Access Compliance Report

Public Rights-of-Way

(Curb Ramps)

Intersection ID: 3145	Main Street: BASKERVILLE_AV	Cross Street: PALLADIUM_PL	Location: S
ADA ID: 7476084B3F64	Ramp Type: Perp	Initial Pass/Fail: Fail	Overall Compliance: No
Severity Score: 12.5			
Codes/Mitigation Info/Possible Solution		Field Measurements/Component Compliance

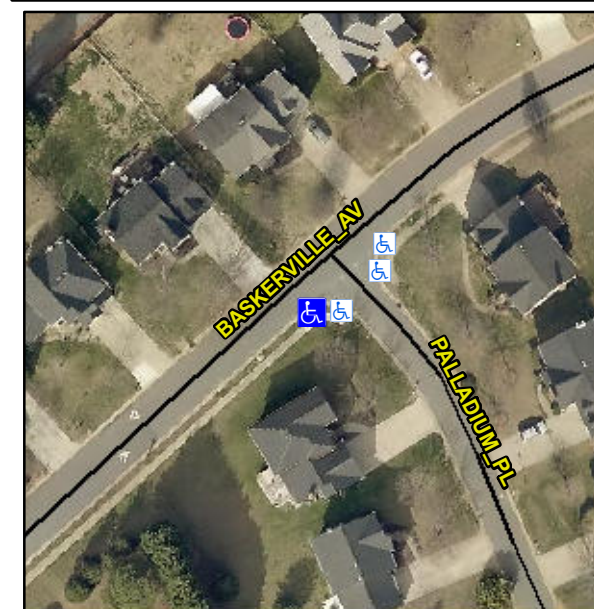
PROW/ADA:

Not Found, R304.2.2

Compliance	Description	Data	Compliance	Description	Data
N/A	Ramp Length (in)	46.0	No	Ramp Slope (%)	9.1
Yes	Ramp Width (in)	64.0	Yes	Ramp XSlope (%)	0.2
N/A	Flare Type LT	N/A	N/A	Flare Type RT	N/A
N/A	Flare Slope LT (%)	N/A	N/A	Flare Slope RT (%)	N/A
N/A	Flare Traversable LT?	N/A	N/A	Flare Traversable RT?	N/A
N/A	Landing Length (in)	N/A	N/A	DWS Provided?	N/A
N/A	Landing Width (in)	N/A	N/A	DWS Contrast?	N/A
N/A	Landing Slope (%)	N/A	N/A	DWS Length (in)	N/A
N/A	Landing X Slope (%)	N/A	N/A	DWS Full Width?	N/A
N/A	Landing Curb? (Y/N)	N/A	N/A	DWS Offset (in)	N/A
N/A	Shared Landing?	N/A			
N/A	Gutter Ponding?	N/A	N/A	Gutter Slope (%)	N/A
N/A	Gutter Lip Ht (in)	N/A	N/A	Gutter X Slope (%)	N/A
N/A	Painted X Walk1?	No	N/A	Painted X Walk2?	N/A
	X Walk 1 Direction	To NW		X Walk 2 Direction	N/A
N/A	X Walk 1 Width (in)	N/A	N/A	X Walk 2 Width (in)	N/A
	X Walk 1 Slope (%)	5.0		X Walk 2 Slope (%)	N/A
	X Walk 1 X Slope (%)	0.4		X Walk 2 X Slope (%)	N/A

Possible Solutions:

Remove & Replace Entire Ramp.
